Final Set, Jefferson Village Phase II  
(Bulletin 6)

JEFFERSON VILLAGE

TYPICAL PAVEMENT CROSS SECTIONS

HOR. SCALE: NO SCALE  
VER. SCALE: NO SCALE  
DATE: 3-27-00  
JOB NO.: DE99011  
FILE NO.: DE9911X1  
SHEET NO.: P-0.2

HARDING AVE. STA. 191+00 TO STA. 201+50  
 PAVING - PLAN & PROFILE

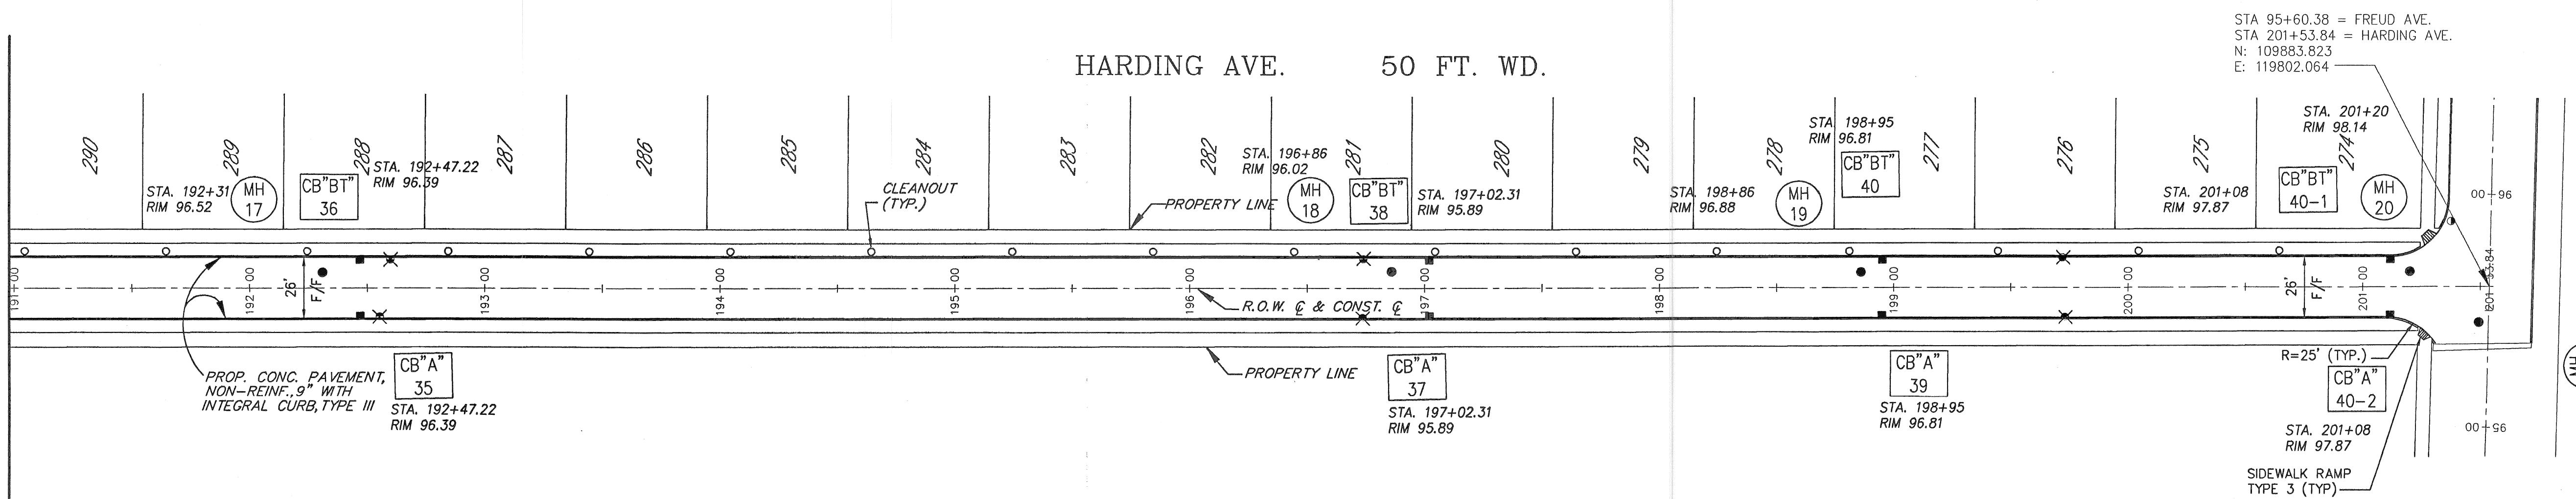
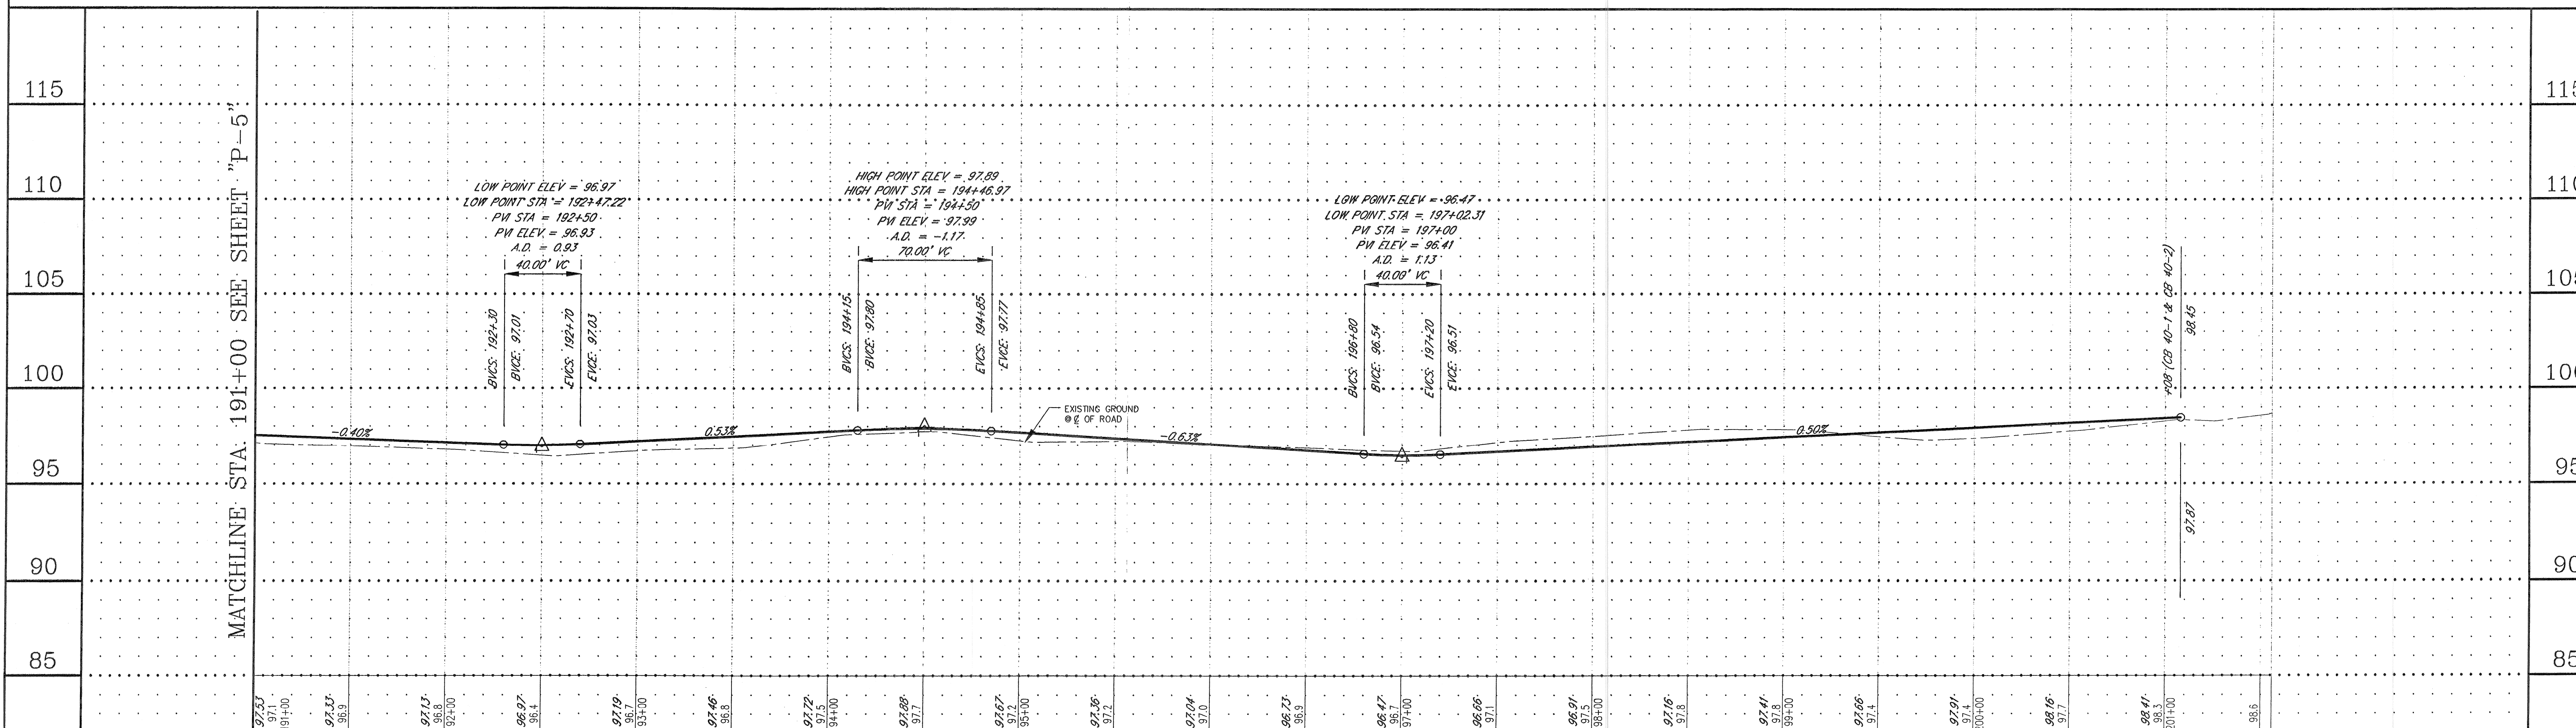
**NOTE:**  
 THE TYPE OF CURB WAS CHANGED FROM 7" HIGH STRAIGHT FACE TO 4" HIGH ROLLED CURB AFTER THE PREPARATION OF THE PAVING PLANS AND PROFILES (EXCEPTING FOR FREUD, MARQUETTE AND NEW STREET BETWEEN BENVENUE AND ST. JEAN). THE PAVEMENT ELEVATIONS AS SHOWN ON THE INTERSECTION DETAILS SHEETS SHALL BE MAINTAINED. ONLY THE TOP OF CURB ELEVATIONS SHALL BE DROPPED BY 0.25' (3"). THIS SHALL BE ACHIEVED BY SUBTRACTING 0.25' (3") FROM THE TOP OF CURB ELEVATIONS SHOWN ON THE PROFILES.

**NOTE:**  
 CB "A" AND CB "BT" SHALL BE TRAPPED WITH THROTTLED COVER, TYPE B.

MEADOWBROOK AVE. STA. 210+00 TO STA. 220+50  
 PAVING - PLAN & PROFILE

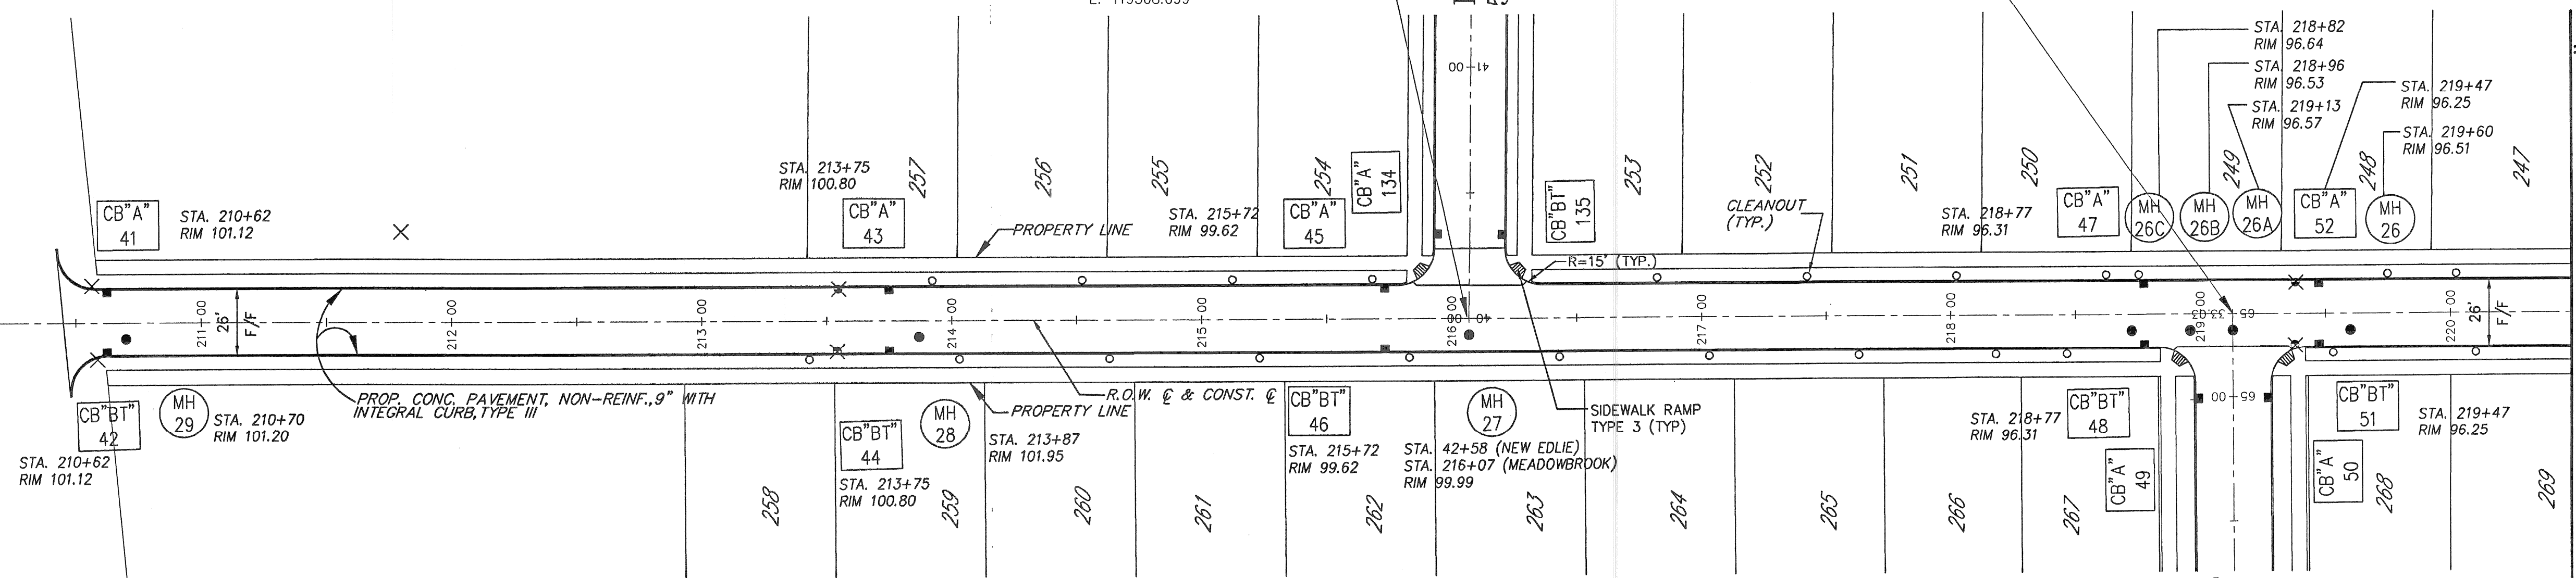
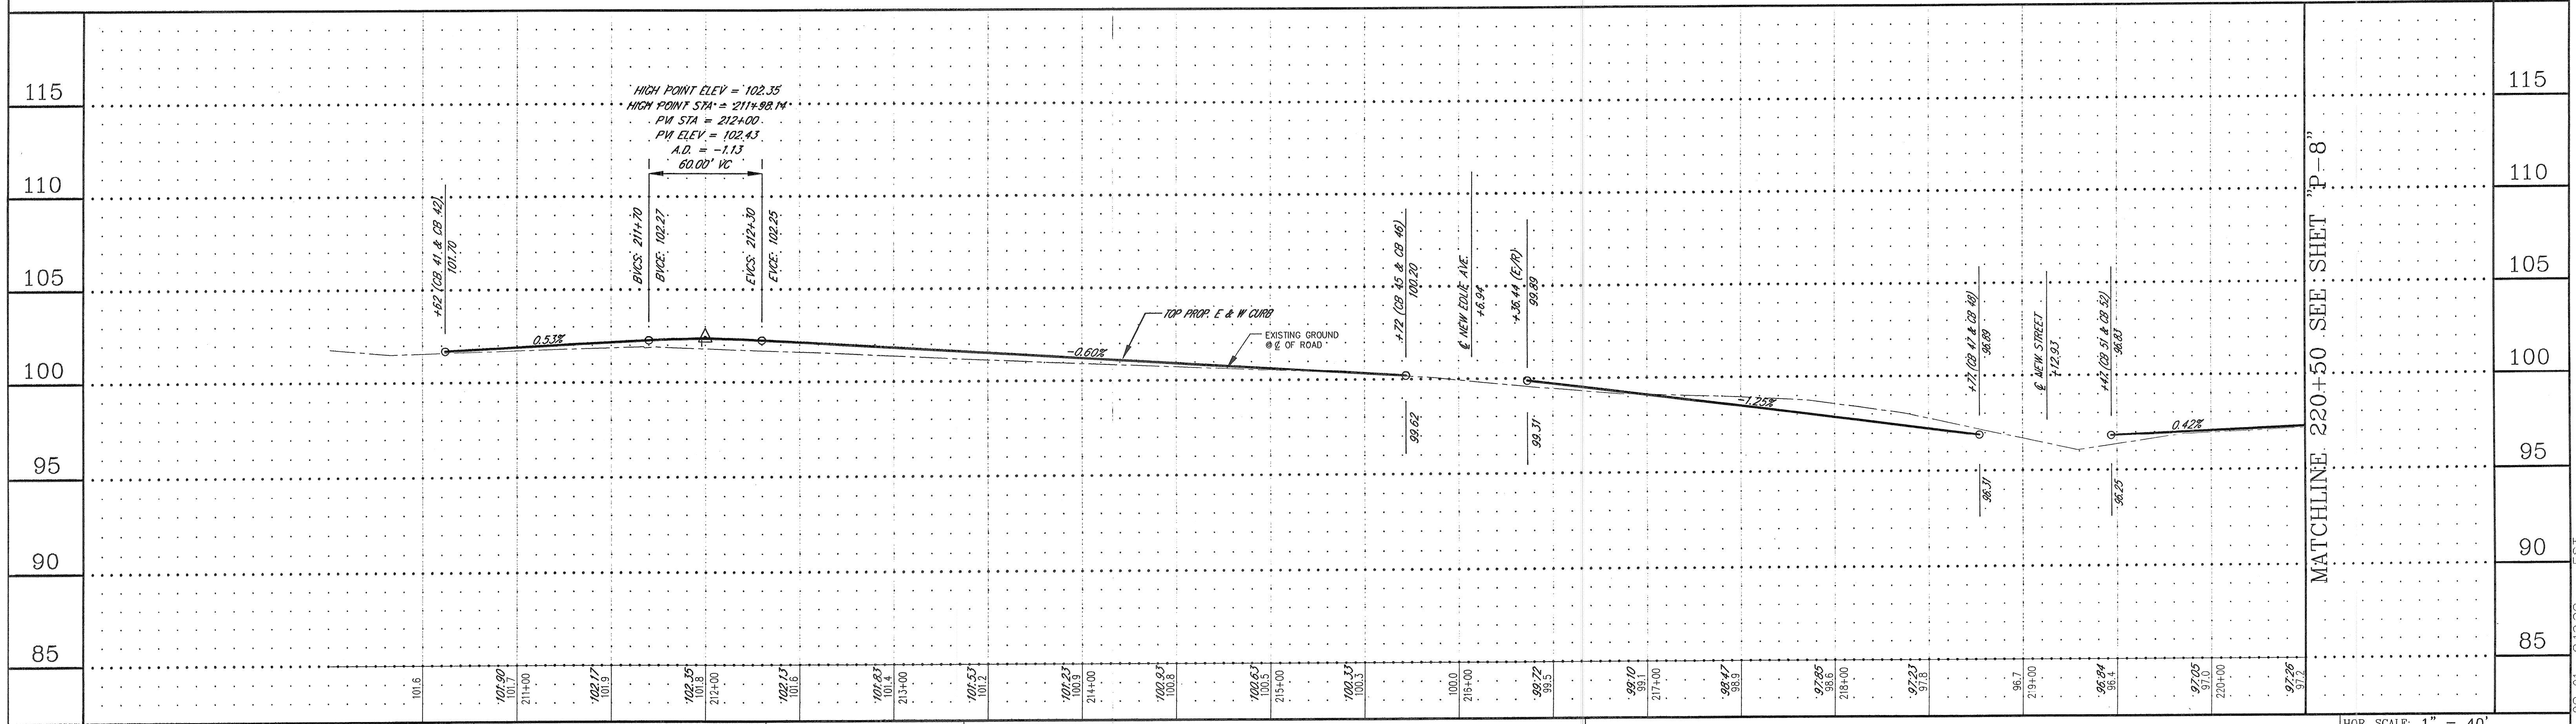
THE TYPE OF CURB WAS CHANGED FROM 7" HIGH STRAIGHT FACE TO 4" HIGH ROLLED CURB AFTER THE PREPARATION OF THE PAVING PLANS AND PROFILES (EXCEPTING FOR FREUD, MARQUETTE AND NEW STREET BETWEEN BENEITEAU AND ST. JEAN). THE PAVEMENT ELEVATIONS AS SHOWN ON THE INTERSECTION DETAILS SHEETS SHALL BE MAINTAINED. ONLY THE TOP OF CURB ELEVATIONS SHALL BE DROPPED BY 0.25' (3"). THIS SHALL BE ACHIEVED BY SUBTRACTING 0.25' (3") FROM THE TOP OF CURB ELEVATIONS SHOWN ON THE PROFILES.

NOTE:  
 CB "A" 47 TO CB "A" 52 SHALL BE TRAPPED WITH THROTTLED COVER, TYPE B.

MEADOWBROOK AVE. STA. 220+50 TO STA. 232+00  
PAVING - PLAN & PROFILE

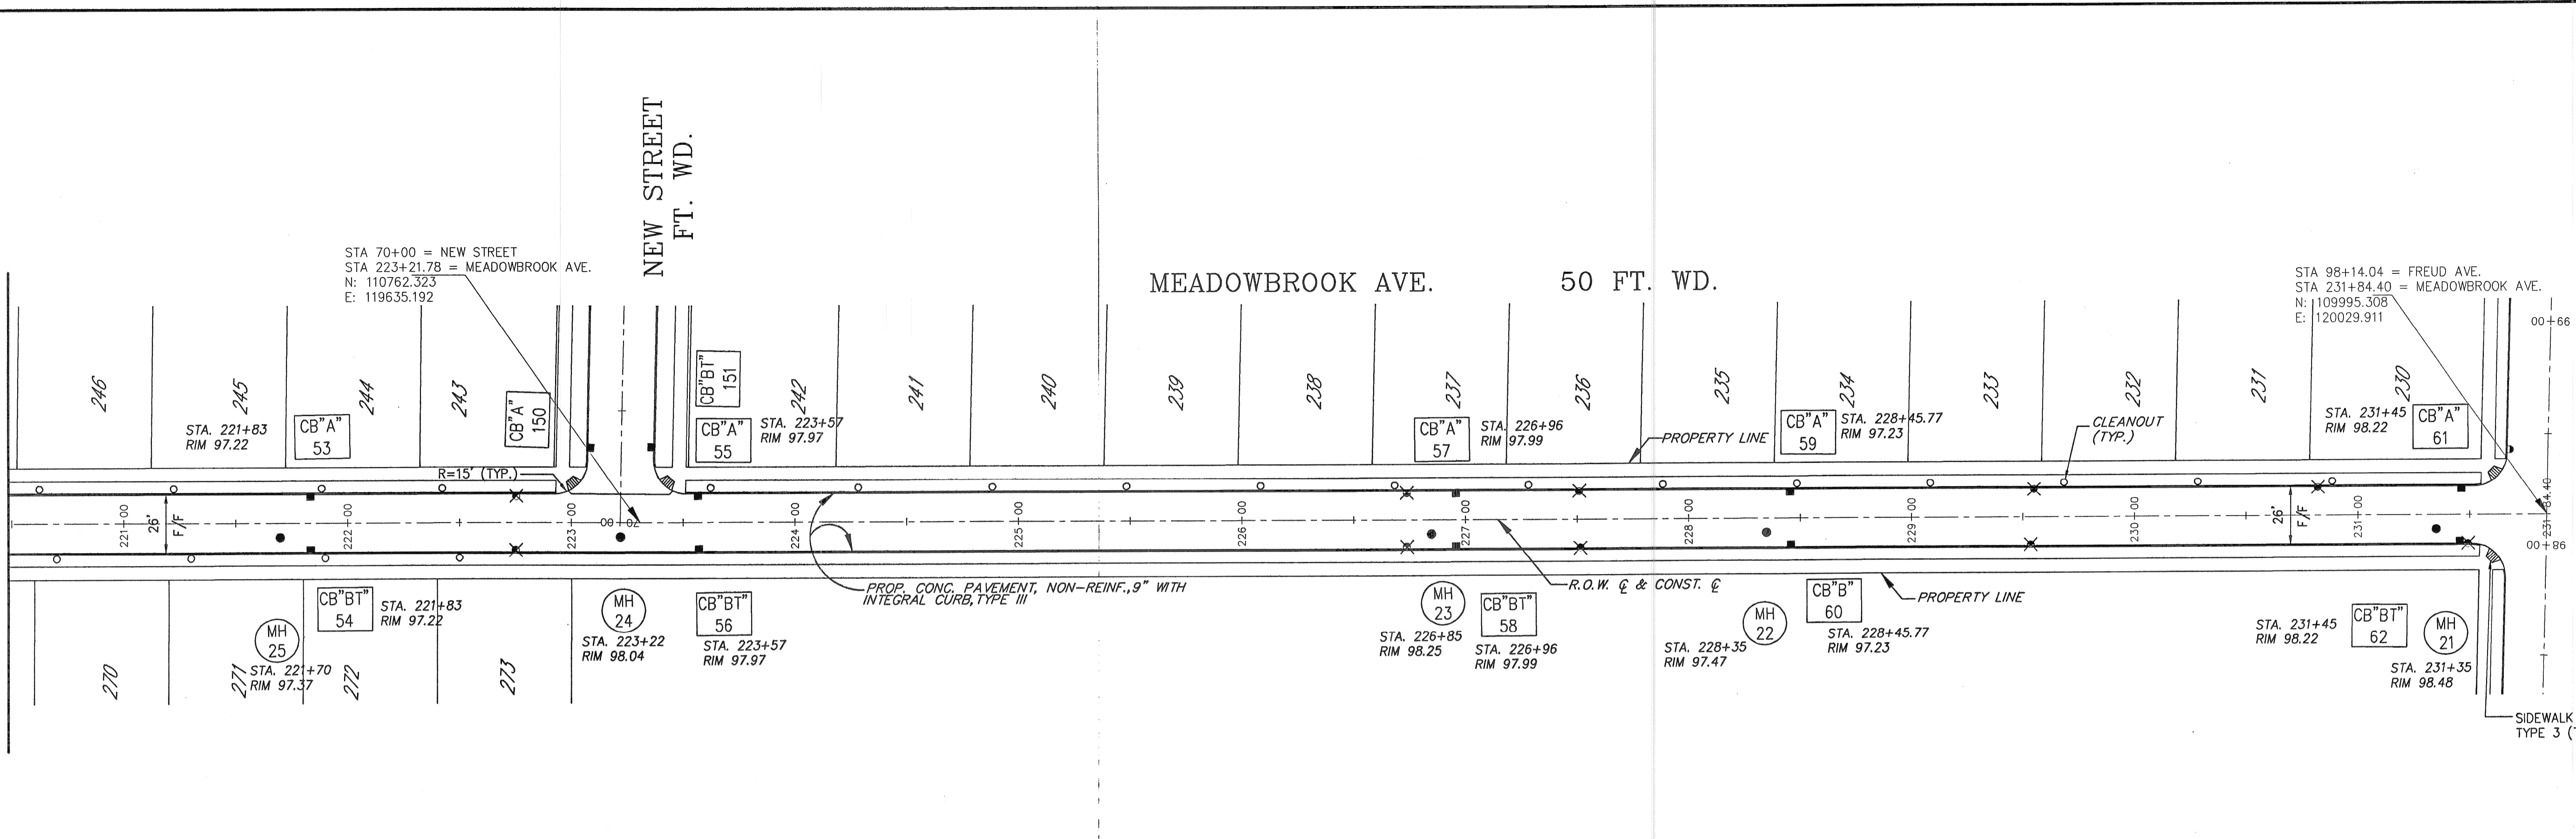
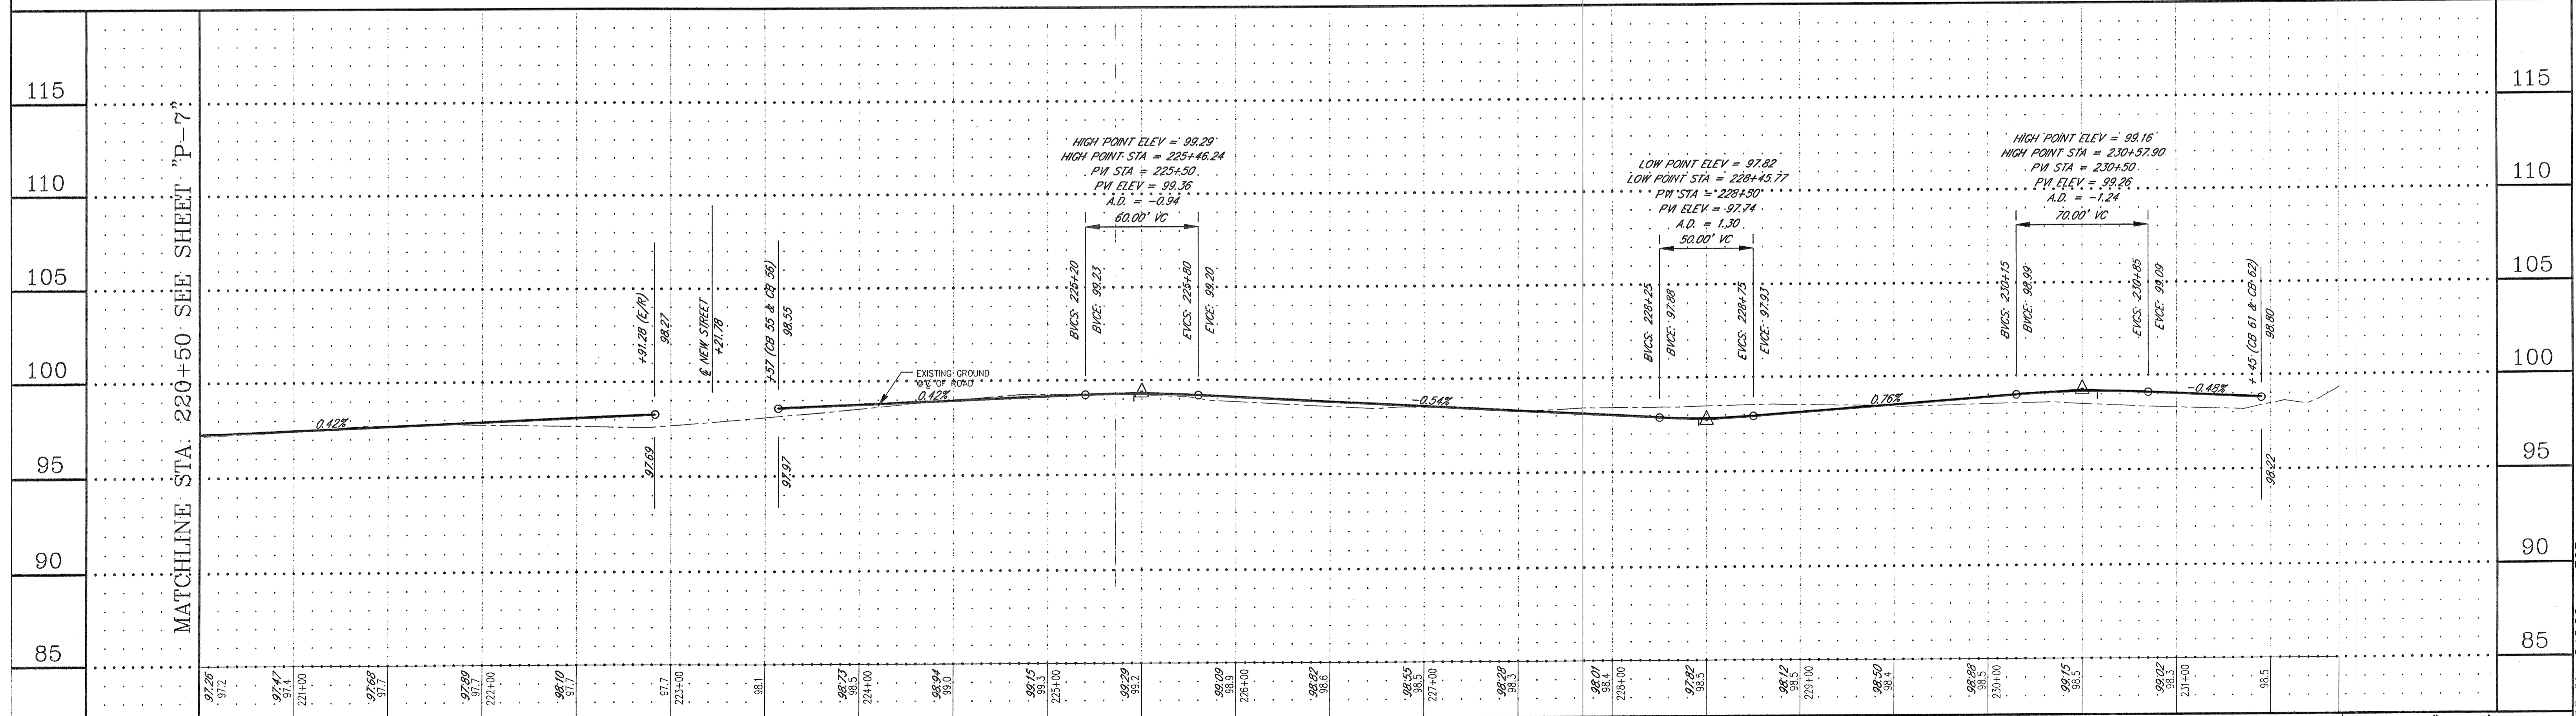
**NOTE:**  
THE TYPE OF CURB WAS CHANGED FROM 7" HIGH STRAIGHT FACE TO 4" HIGH ROLLED CURB AFTER THE PREPARATION OF THE PAVING PLANS AND PROFILES (EXCEPTING FOR FREUD, MARQUETTE AND NEW STREET BETWEEN BENITEAU AND ST. JEAN). THE PAVEMENT ELEVATIONS AS SHOWN ON THE INTERSECTION DETAILS SHEETS SHALL BE MAINTAINED. ONLY THE TOP OF CURB ELEVATIONS SHALL BE DROPPED BY 0.25' (3"). THIS SHALL BE ACHIEVED BY SUBTRACTING 0.25' (3") FROM THE TOP OF CURB ELEVATIONS SHOWN ON THE PROFILES.

**NOTE:**  
CB "A" 59 AND CB "BT" 60 SHALL BE TRAPPED WITH THROTTLED COVER, TYPE B.
